I want to thank ICF and the EPA for the opportunity to comment on the Draft Battery Charging Systems Specification. I think it has been good that the EPA and the Cadmus group have been so willing to listen to us manufacturers and improve the standard with industry input. The document looks very good regarding the test method and general information. I only have three issues, which I feel need to be addressed.

48-Hour Energy Use Normalized by Battery Energy and Projected Annual kWh Consumption Graphed on Battery Voltage

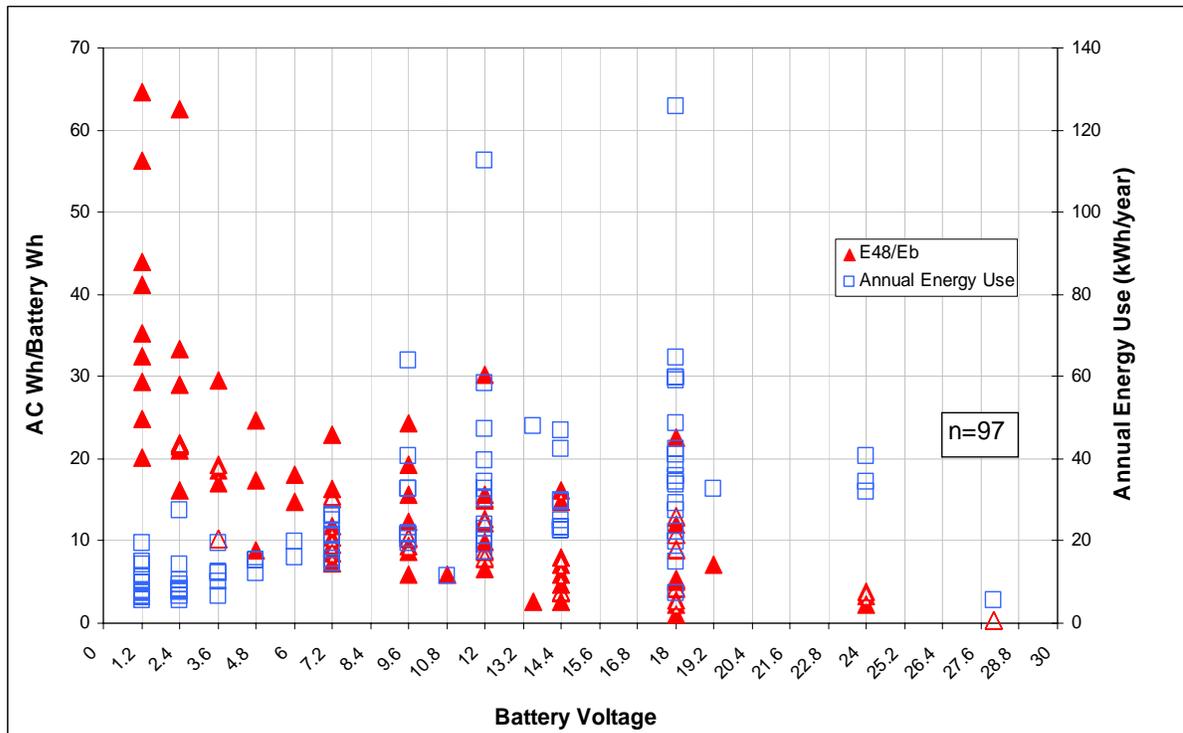
3) I still do not agree with having a specification for products under 1.5 volts. The amount of energy saved is not going to be worth the initial investment. If we look at your chart below and we could make the worst product in the 1.2 volt category 50% better we could go from 19 KWh per year to 9.5 KWh per year. If we take a rate of \$.08 per KWh you would save **\$0.76** per year.

According to your "Guiding Principles for Energy Star Specification Development" the first two statements: "Significant energy savings potential" and "Purchasers will recover their investment within a reasonable time period" will not be fulfilled in the 1.2 volt category due to the increase in unit price vs. the amount to be saved. This is due to the inefficient diodes when using a linear transformer or power needed to run electronics when using a switching supply.

Energy Ratio vs Battery Size with Same Charger

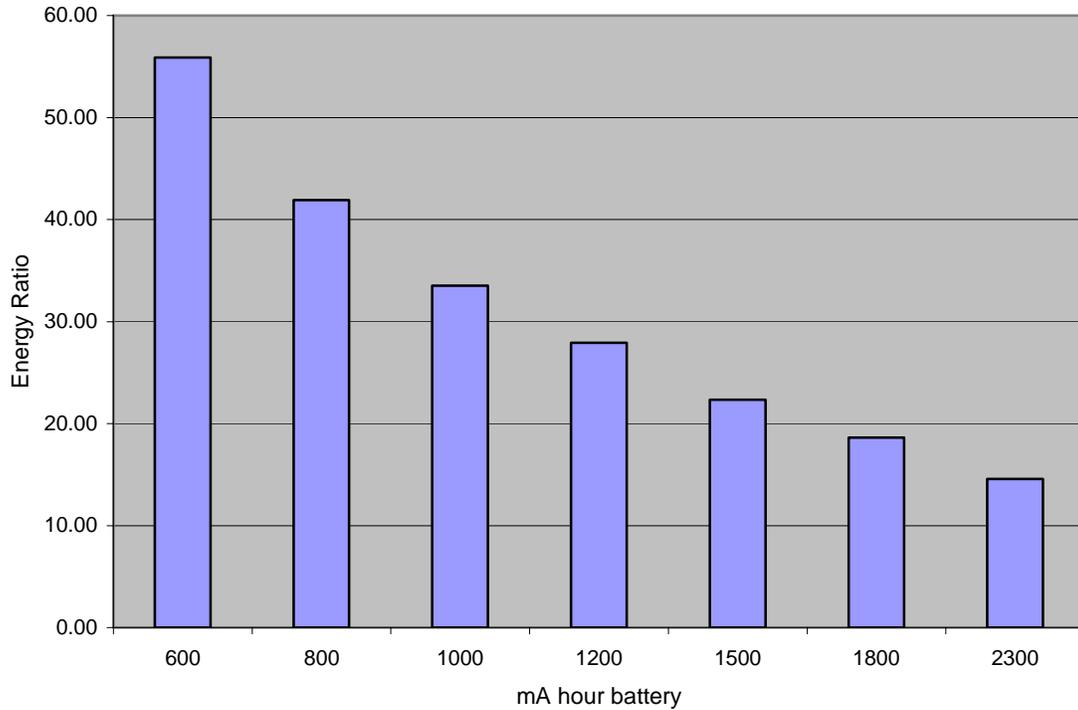
In addition, there is more of a challenge with a one-cell application because the ER formula uses the battery capacity in the denominator, which drastically affects the energy ratio. I have attached a chart below, which shows the effect the battery capacity can have on the energy ratio without changing the charging system. This is another reason why units under 1.5 volts should be excluded.
